DART AEROSPACE LTD		Work Order:	116478
Description: Crosstube Assembly		Part Number:	D407-667-245
Inspection Dwg: D407-667-245 Rev: F		Page 1 of 2

DESIGN	47	DART AEROSPACE LTD	
DRAWN	RF	HAWKESBURY, ONTARIO, CANADA	
CHECKED	47	DRAWING NO.	REV. F
MFG. APPR.	47	D407-667-245	SHEET 4 OF 4
APPROVED	47	TITLE	SCALE
DE APPR.	47	CROSSTUBE ASSY (407 HIGH AFT)	NTS
DATE	08.11.06	COPYRIGHT © 2002 BY DART AEROSPACE LTD	
THIS DOCUMENT IS PRIVATE AND CONFIDENTIAL AND IS SUPPLIED ON THE EXPRESS CONDITION THAT IT IS NOT TO BE USED FOR ANY PURPOSE OR COPIED OR COMMUNICATED TO ANY OTHER PERSON WITHOUT WRITTEN PERMISSION FROM DART AEROSPACE LTD.

DRAWING NO. D407-667-245	TITLE CROSSTUBE ASSY (407 HIGH AFT)	REV. F	DART AEROSPACE LTD ENGINEERING ORDER		D.E.O. NO. D407-667-245-F-1	SHEET NO. SHEET 1 OF 2	SCALE NTS
DRAWN <i>[Signature]</i>	CHECKED <i>[Signature]</i>	MFG. APPR. <i>[Signature]</i>	APPROVED <i>[Signature]</i>		DE APPR. <i>[Signature]</i>		
DATE 11.04.08	DATE 11.04.12	DATE 11.04.12	DATE 11.04.12		DATE 11.04.12

DRAWING NO. D407-667-245	TITLE CROSSTUBE ASS'Y (407 HIGH AFT)	REV. F	DART AEROSPACE LTD ENGINEERING ORDER		D.E.O. NO. D407-667-245-F-2	SHEET NO. SHEET 1 OF 1	SCALE NTS
DRAWN <i>JP</i>	CH

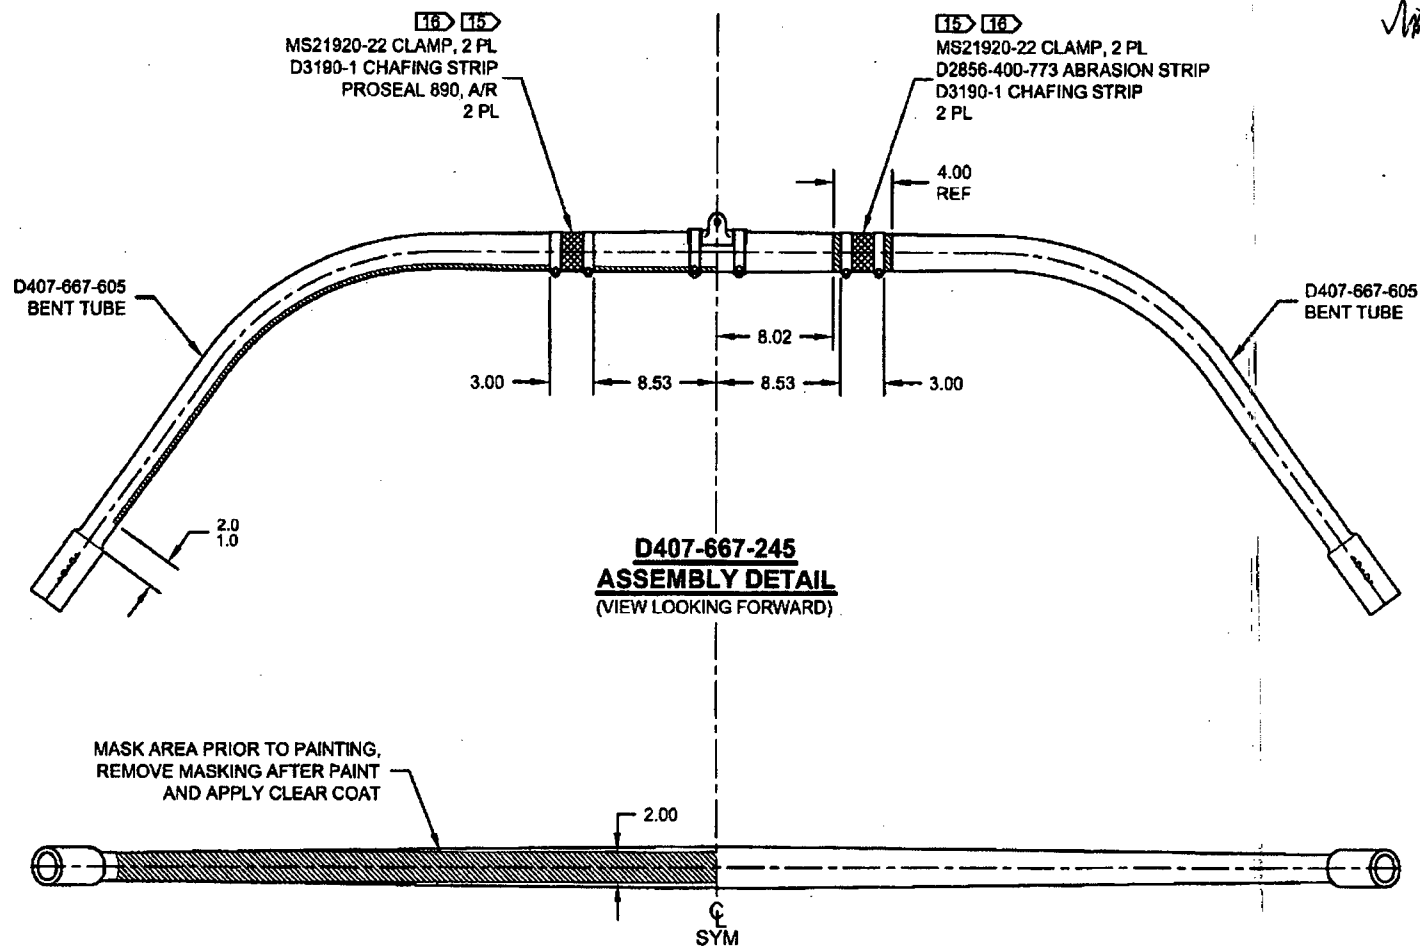
REMOVED ABRASION STRIP IN FAVOR OF A THIN LAYER OF PROSEAL 890.

PARTS LIST IS AMENDED AS FOLLOWS:

NOTES 2 AND 15, SHEET 1 ARE AMENDED AS FOLLOWS:

- 2) FINISH: CHEMICAL CONVERSION COAT PER DART QSI 005 4.1
PRIME INSIDE AND OUTSIDE PER DART QSI 005 4.2
MASK UNDERSIDE OF CROSSTUBE AS SHOWN (HATCHED AREA) AND
PAINT OUTSIDE PER DART QSI 005 4.2
REMOVE MASKING AND APPLY CLEAR COAT
- 15) APPLY A THIN COAT OF PROSEAL 890 ON INSIDE CONCAVE SURFACE OF D3190-1
CHAFING SHIELDS AND LET CURE PER MANUFACTURER'S INSTRUCTIONS. INSTALL
PROSEALED D3190-1 CHAFING SHIELDS ONTO CROSSTUBE BY APPLYING A THIN COAT
OF PROSEAL 890 ONTO CROSSTUBE. BE SURE TO ELIMINATE ANY AIR GAPS.
